TO:	CHAIR AND MEMBERS PLANNING AND ENVIRONMENT COMMITTEE
FROM:	G. KOTSIFAS DIRECTOR OF BUILDING CONTROLS AND CHIEF BUILDING OFFICIAL
SUBJECT:	APPLICATION BY: 905 SARNIA ROAD INC. 895 AND 905 SARNIA ROAD NORTH PORTION PUBLIC PARTICIPATION MEETING ON MARCH 23, 2015

39T-14501/Z-8395
C. Smith

Submitted Draft Plan

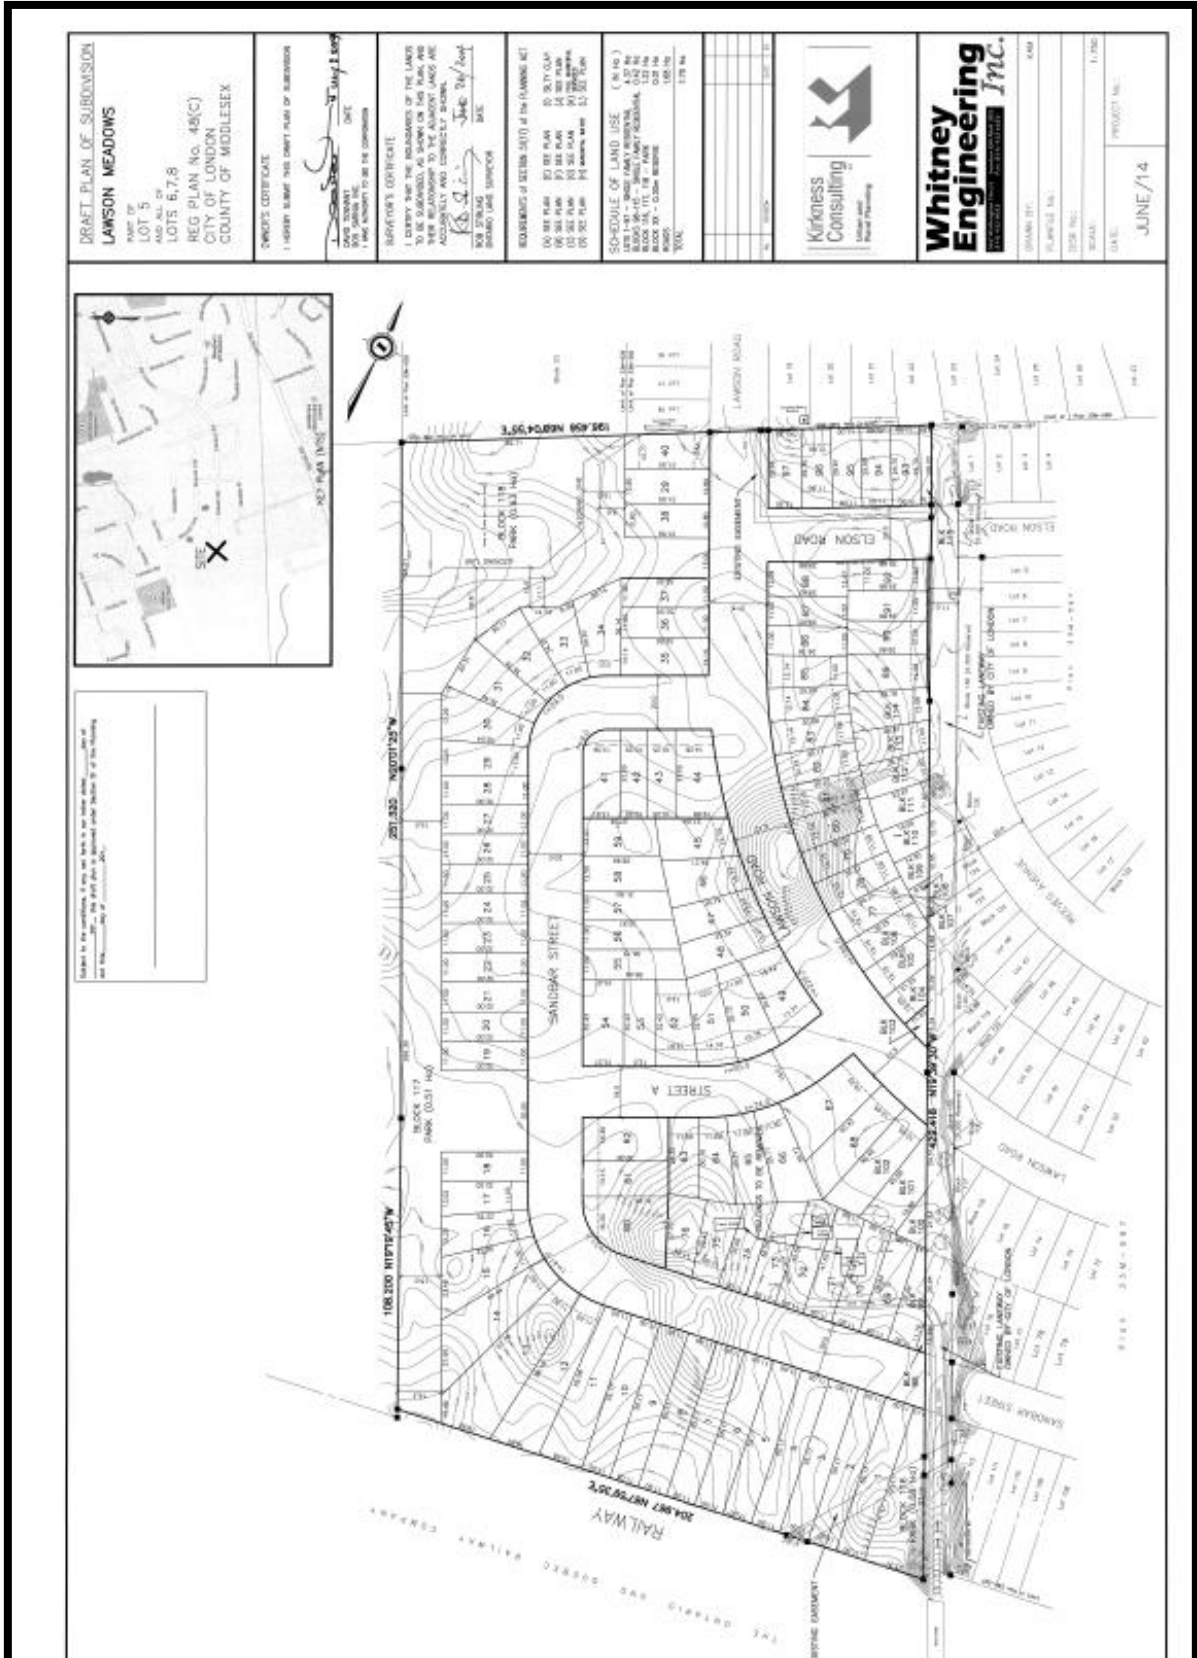
- Connect to the existing 200 mm municipal sanitary sewer located on Lawson Road at the north end of the plan.

- To serve the north portion this plan (approx. 2.7 ha), connect to the existing 600 mm diameter storm sewer municipal storm sewer system, located on Lawson Road, at the north limit of this plan.
- To serve the south portion of this plan, connect to the proposed storm system outlet on Park Block 117 in this Plan.

- Construct watermains to serve this Plan and connect them to the existing municipal system as follows:
 - to the 300 mm diameter watermain on Lawson Road at the north limit of this plan;
 - the 300 mm diameter watermain on Lawson Road at the east limit of this plan;
 - the 200 mm diameter watermain on Sandbar Street at the east limit of this plan; and
 - the 200 mm diameter watermain on Elson Road at the east limit of this plan.
- Deliver confirmation that the watermain system has been looped to the satisfaction of the City Engineer when development is proposed to proceed beyond 80 units.

- The Owner shall provide sufficient lands abutting Lots 89 to 92 and Block 114 in this Plan to complete Reeves Avenue with a 20.0 metre right-of-way in conjunction with the portion of Reeves Avenue in Plan 33M-597 and the "unnamed" road allowance in Registered Plan 48(c) and convey the said lands in this Plan to the City at the time the Plan is registered, to the satisfaction of the City Engineer and at no cost to the City

- The Owner shall construct a 1.5 metre sidewalk on both sides of Lawson Road to connect to the existing sidewalks in abutting developments 33M-585 (at the north limit of this plan) and 33M-597 (at the east limit of this plan), to the satisfaction of the City Engineer and at no cost to the City

- Sandbar Street – outside boulevard, connecting to the existing sidewalk in 33M-597 at the east limit of this plan;
 - Street ‘A’ - south boulevard;
 - Elson Road – north boulevard, connecting to the existing sidewalk in 33M-597 at the east limit of this plan; and
 - Reeves Avenue – west boulevard.
- The Owner shall have its professional engineer design and construct the traffic calming measures along the secondary collector road network in this Plan

Staff Response: Conditions to support the Engineering comments have been added to the draft plan and addressed through specific holding provisions attached to the zoning.

CP Rail

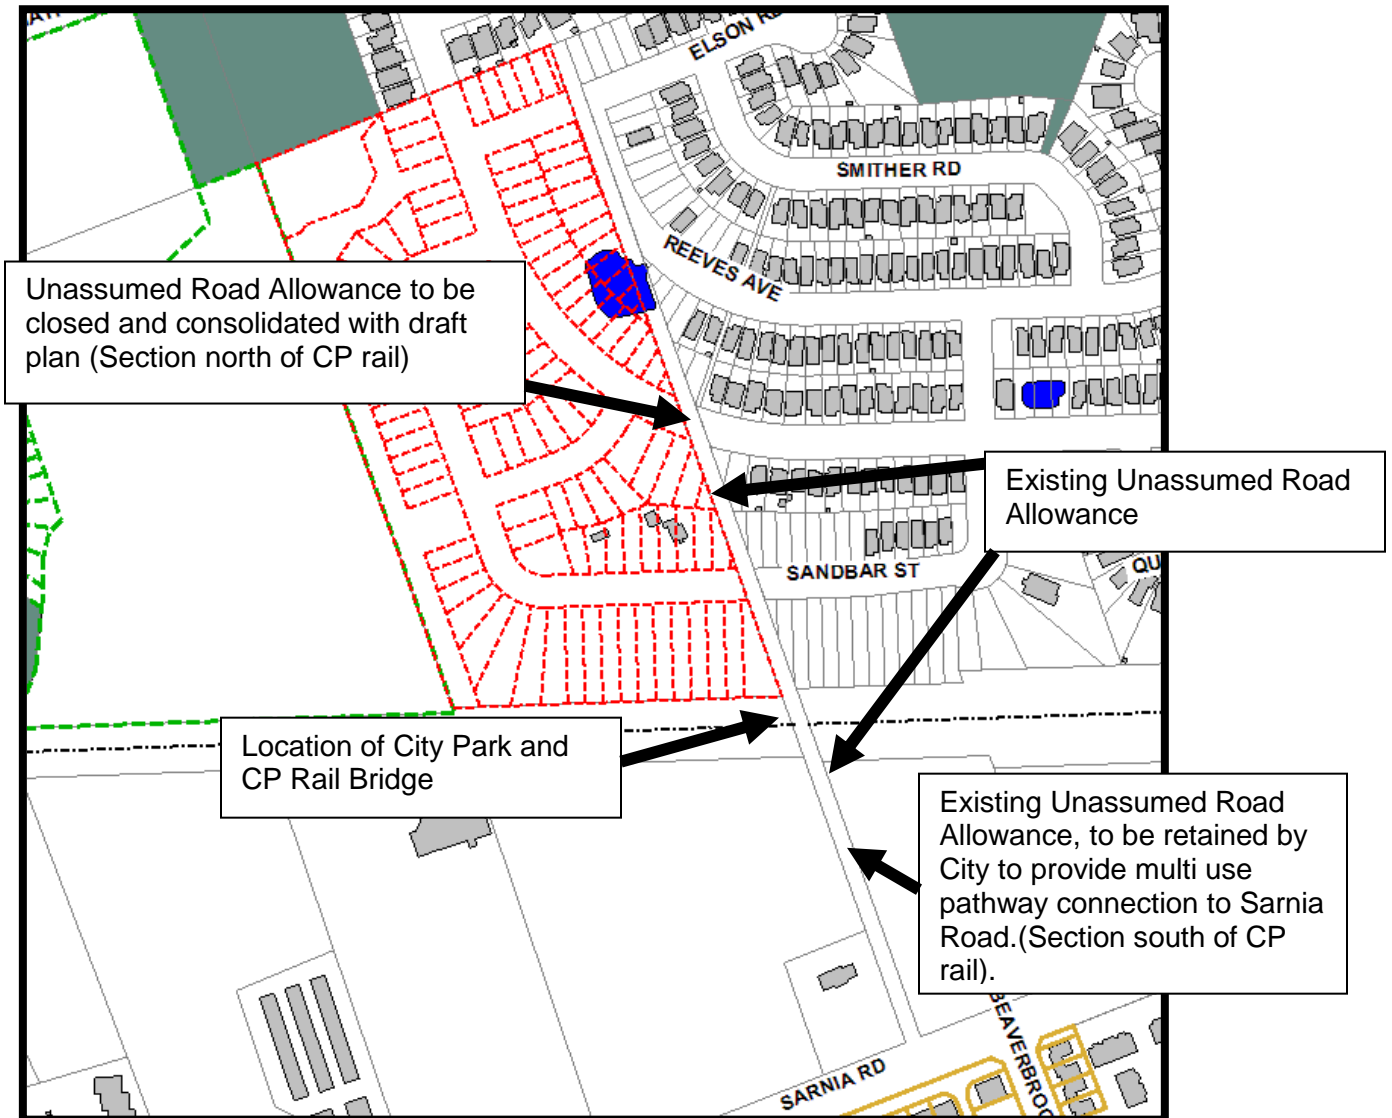
The CP rail right-of-way is located along the southerly boundary of the plan of subdivision. Lots 1-13 are proposed to be rear lotted along the rail road right-of-way. The rear lotting is a continuation of the same form of development as existing on Sandbar Street to the east. Through the recommendations as contained in the submitted Noise Assessment Study and CP Rail requirements, noise, vibration and safety mitigation measures will be required. The applicant will be required to install a safety berm with a noise wall and a safety fence 1.8 m in height. The mitigation measures will be required to be installed along the rear yards of proposed lots 1-13. Draft plan conditions are proposed to ensure that the mitigation measures as required by CP Rail and the Noise Assessment Study are constructed and maintained. A minimum setback of 30 metres is required from the CP rail right-of-way to any habitable space. A special provision has been included in the proposed by-law amendment to implement the required setback.

A rail road bridge exists on the southeast corner of the plan of subdivision. This bridge was originally built (circa 1865) to provide agricultural access across the CP Rail right-of-way. The bridge is listed as priority 1 in the City of London Heritage Inventory. Staff is currently in the process of discussion with CP Rail to ensure that the bridge be retained and used as a
